# SILVERTON WINDFARM SUBMISSION MADE IN RESPONSE TO EXHIBITION DOCUMENTS 2016

Incomplete Impact Assessments, no assessments of  
communications interruptions and possible setback  
solution

Map 2 - Pinpointing 3nm circuit and 5nm Eldee Airfield Boundary.

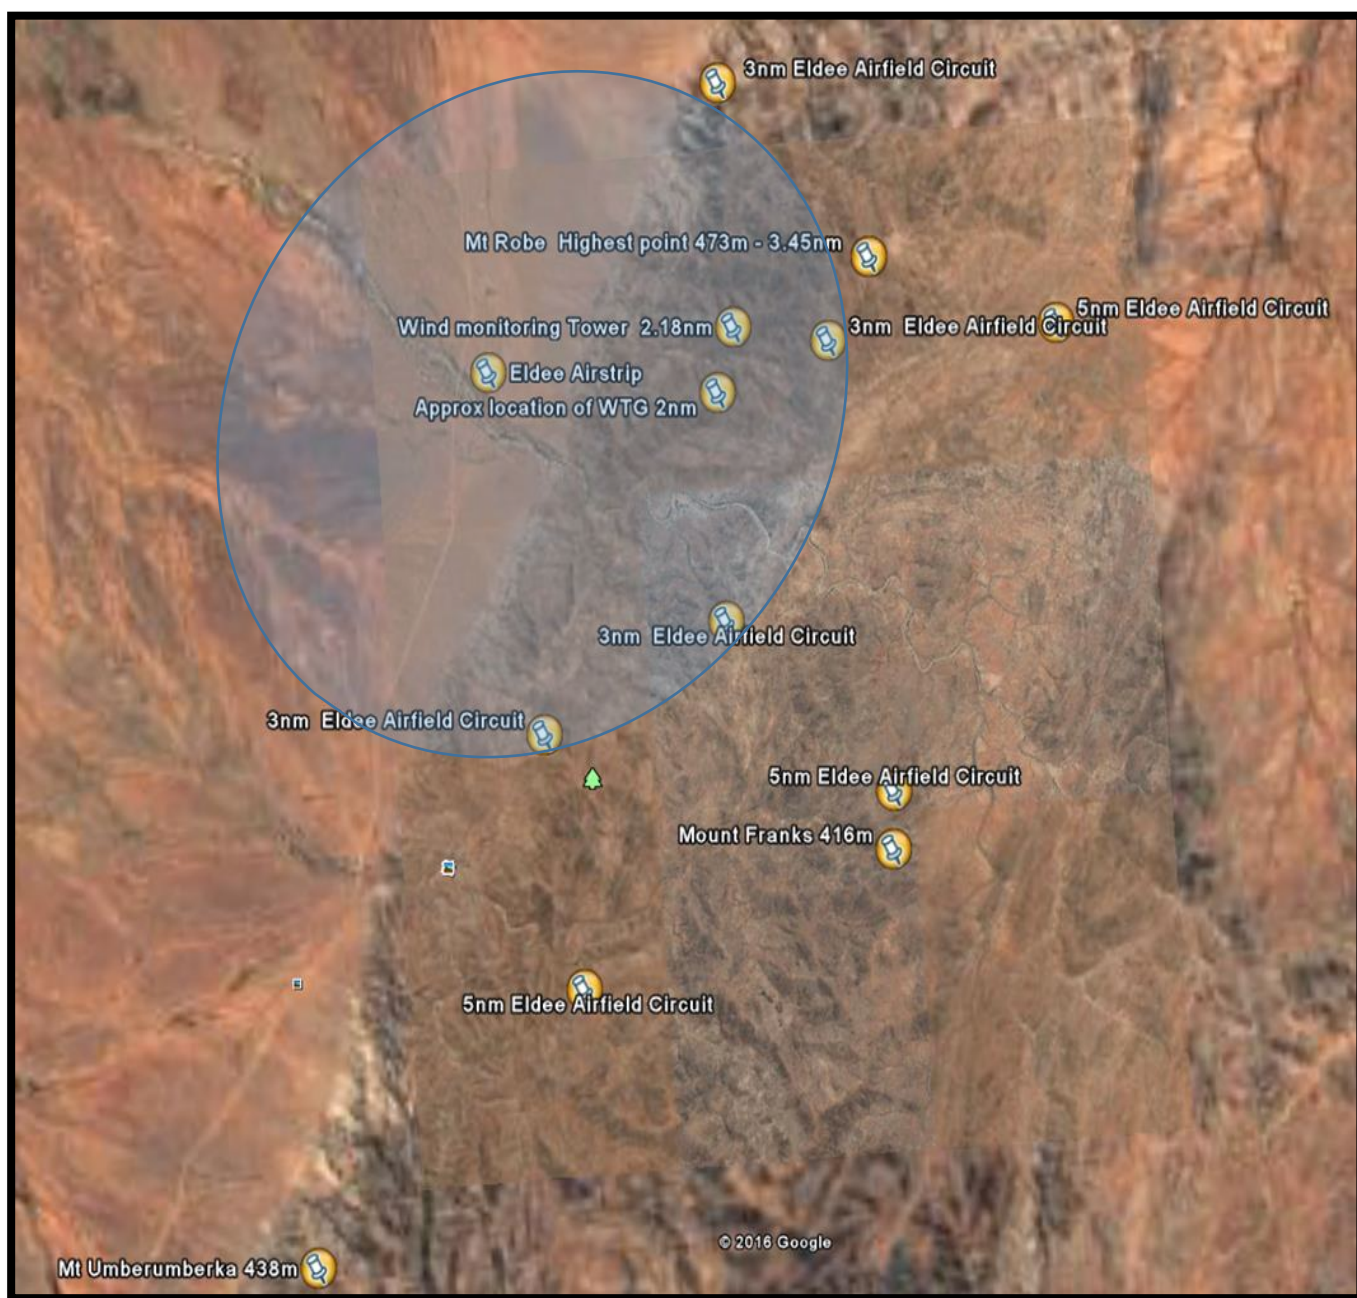
Below is a copy of Google Earth Satellite Map showing the circuit area of 3nm and 5nm for the Eldee Station Airfield. (Please note I do not have the exact coordinates for the boundary of the wind farm nor the turbine locations so the WTG location is an approximate location guided by the location pinpointed in the report).

This map clearly shows that there are turbine locations just 2nm from the Eldee Airfield and will penetrate into LSALT remembering the mandatory circuits for all airfields are 3 nautical miles and 5 nautical miles as shown below. The blue area below indicates approximately the 3nm mark for circuit which is approximately two thirds of the way across the wind farm. The 5nm markers clearly show western boarder of the wind farm again indicating the breach of the wind farm into Eldee airfield boundary.

Figure 1 Google Search

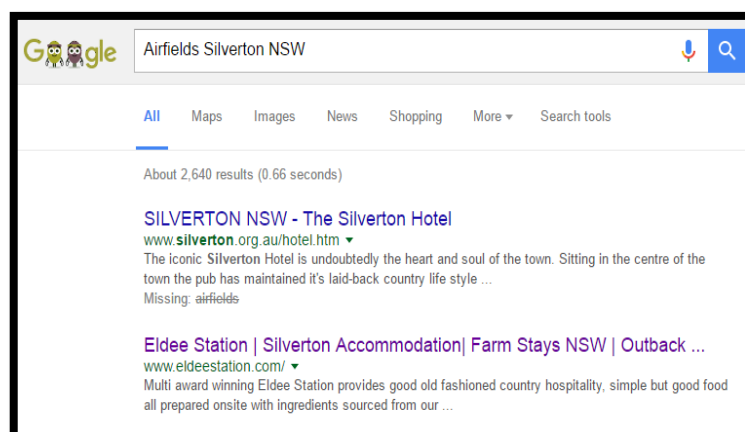
Although the airfield on Eldee Station is a private strip and there are no landing fees the airfield has been advertised widely. A quick desktop search on Google would have immediately identified Eldee Station Airfield in second place as it has been listed on the [www.eldeestation.com](http://www.eldeestation.com) website for many years.

Figure 2 Eldee Station Airfield Webpage for guiding Pilots

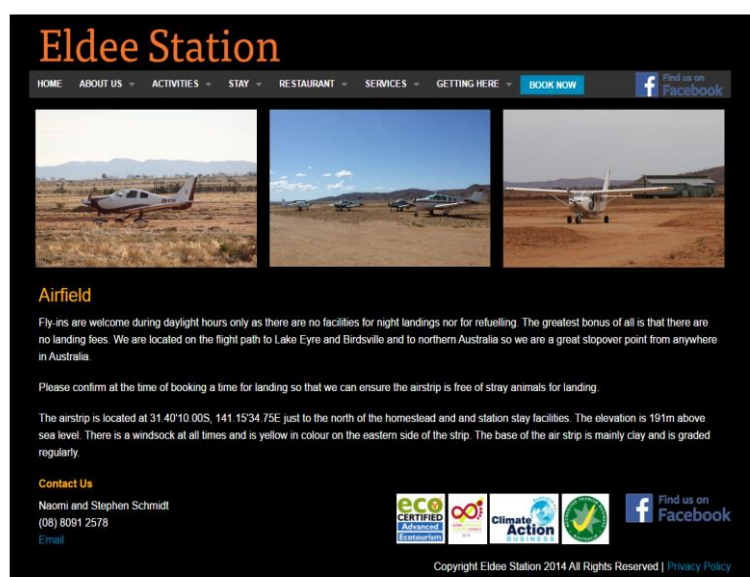
This same airfield is included in the Pilots Touring Guide Book, on HEMA Maps and many other maps.

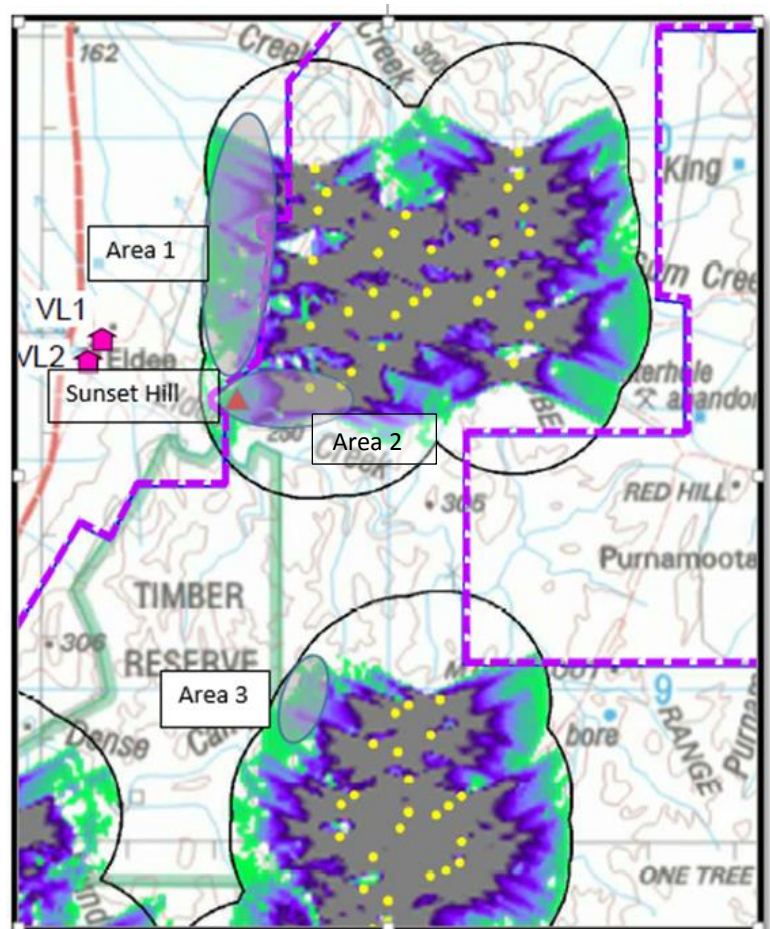
The **Self Drive 4WD tracks** are immediately adjacent to the Barrier Ranges on the slopes and plains to the west on the western boundary of the windfarm. The theoretical shadow from flicker exceeds the wind farm boundary by at least 2 kilometres (denoted by light grey oval). The measurements supplied appear to be very conservative and unrealistic as to impact hours that will be received in this location.

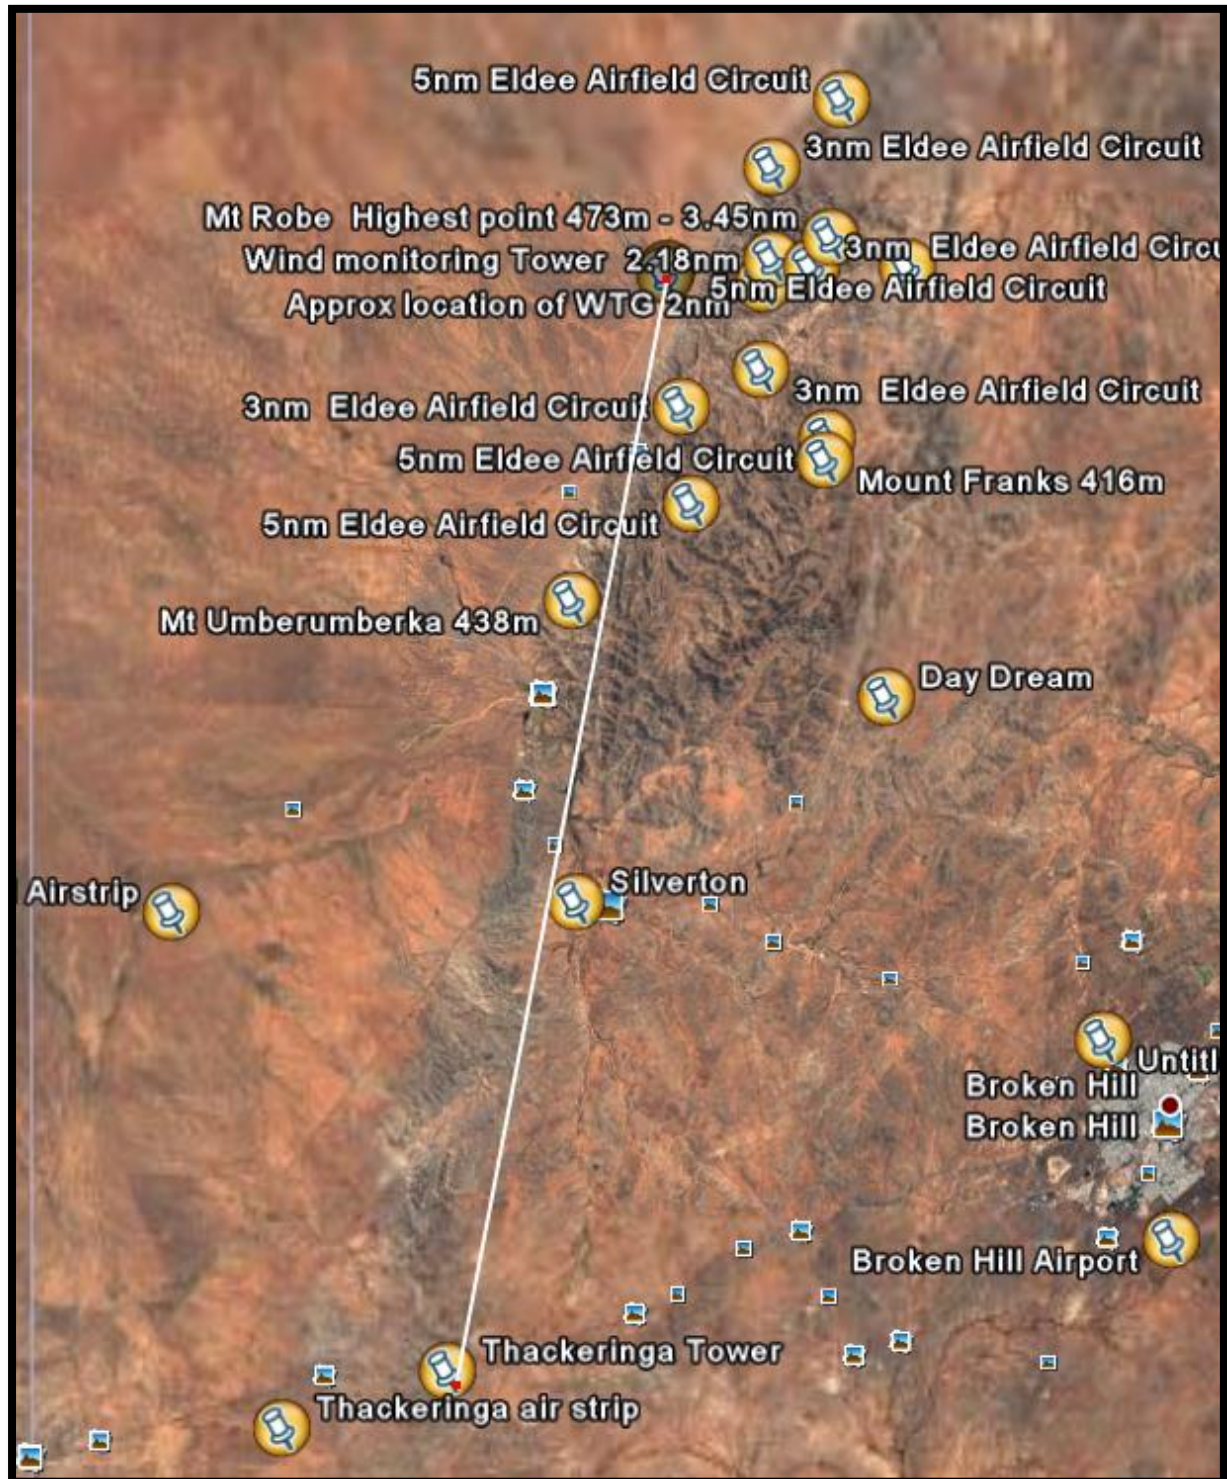
The most outstanding omission in the NIA and the EIS report is the total absence of any data related to Turbines with a generation capacity of 3.6 MW. How can the Department of planning consider increasing the size of the turbines if there is not data presented for consideration and at best guesses as to what might happen with turbines over 3.6MW?

5MW WTG's for onshore use have been manufactured and supplied in Europe since 2014 by reputable companies. This meant that there is data available but has not been included

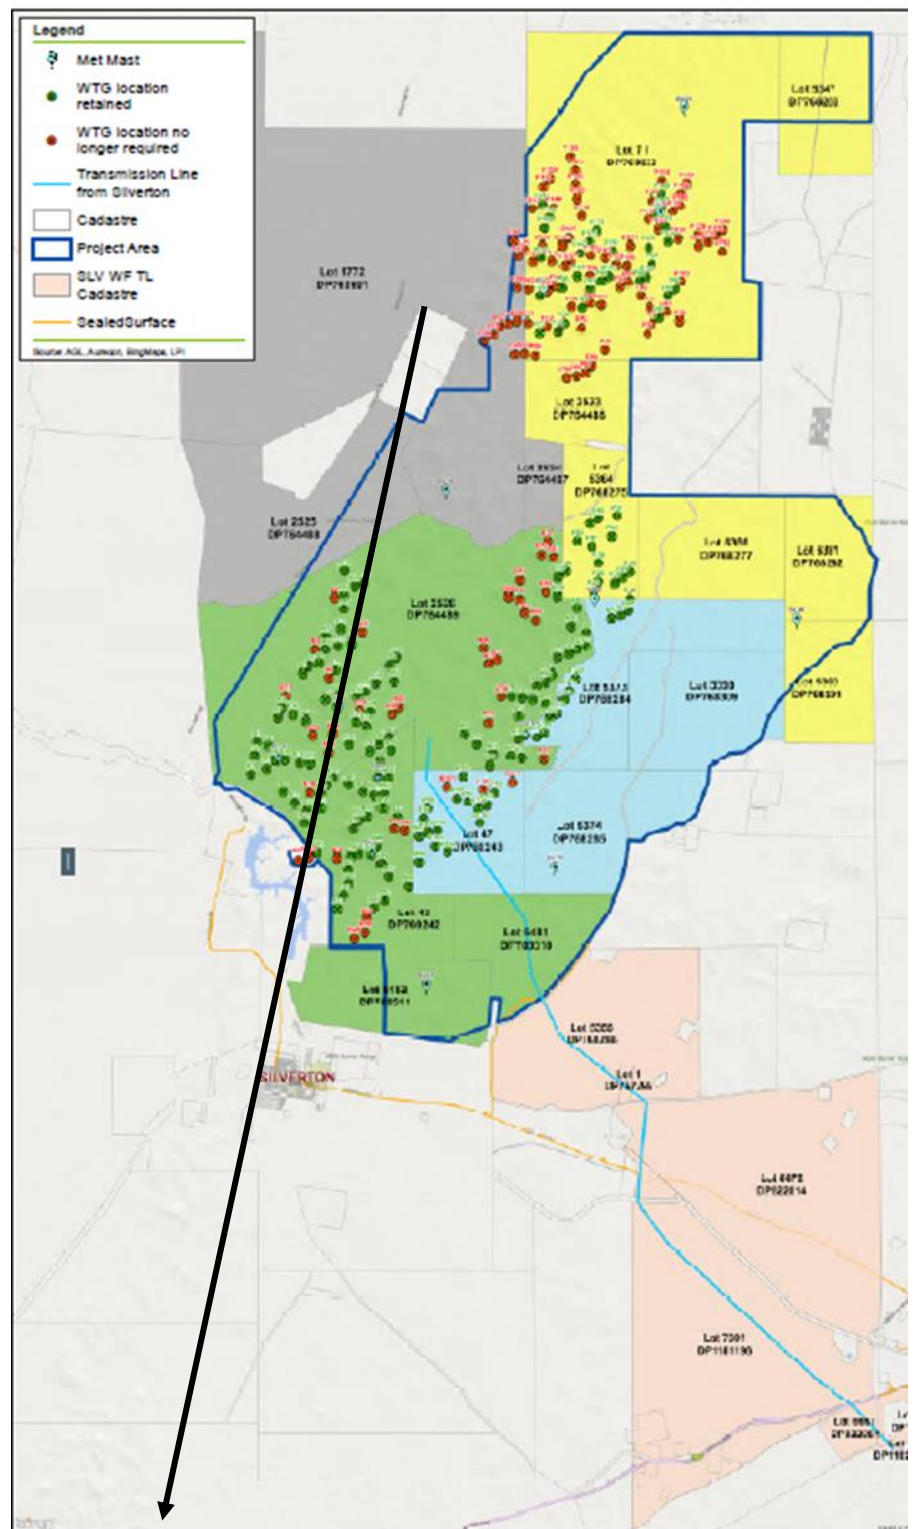
In the Google Map below is a white line to represent the line of sight from the Eldee Homestead to the Thackeringa Phone Tower by Next G wireless local loop which services all of our phone lines, data lines and our mobile phone lines. If the wind turbines are constructed to the south west and western side of the wind farm all of our communications will be totally interrupted as this line illustrates.

On this page there is a black line showing approximately the line of site again to the Thackeringa. Now that the elemental components of the Silvertown Wind Farm Project Approval it is time to consider the negative effects that constructing any towers on the along the south wester and western edge of the Barrier Ranges not only our business and data lines but also our mobile phone connection.

**The current successful signal is line of sight and transmitted at only 45 metres above the earth surface.** At the moment there is **no comparable technology available for our operations.** Satellite does not work through heavy dense clouds when it rains but our current system does.

Although there is an agreement in place which can't be discussed fully it won't overcome this major problem as it stands with added height and interference of our communications systems for phone and data. **Again another reason why the turbines should be clustered as per appendix 1.**

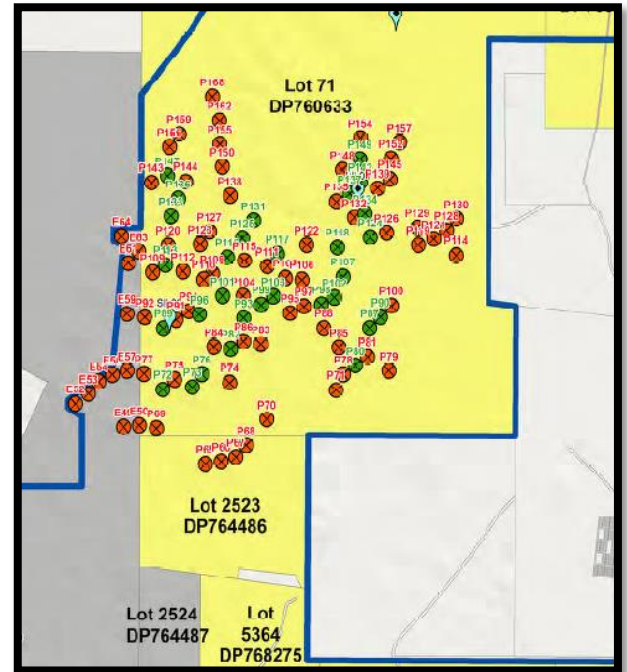
Essentially the solution to the breaches to the Eldee Airfield mandatory circuit of 3nm and the same Airfield boundary, ISALT, and the possible redundancy of the world renowned Sunset Hill Lookout Location could be solved by removing all of the turbine locations in Areas 1 and 2, from the project and retain the concept approval sites and preferred sites identified in Area 3. It would provide a setback from Silverton of 8 Kilometres. The Barrier Ranges topography would also create natural buffers for visual and noise impacts.

The map above is the north section of the Appendix A Maps. Eldee Station lease areas are shown as grey and Purnamoota as yellow. This is the north end of the wind farm project approval and concept approval. The map to left indicates the three areas of concern (included as appendices 1 an enlarged map of map to the right).

It is an ideal time to make these changes to the approval because AGL are asking to reduce turbine numbers from 282 to a maximum of 172.
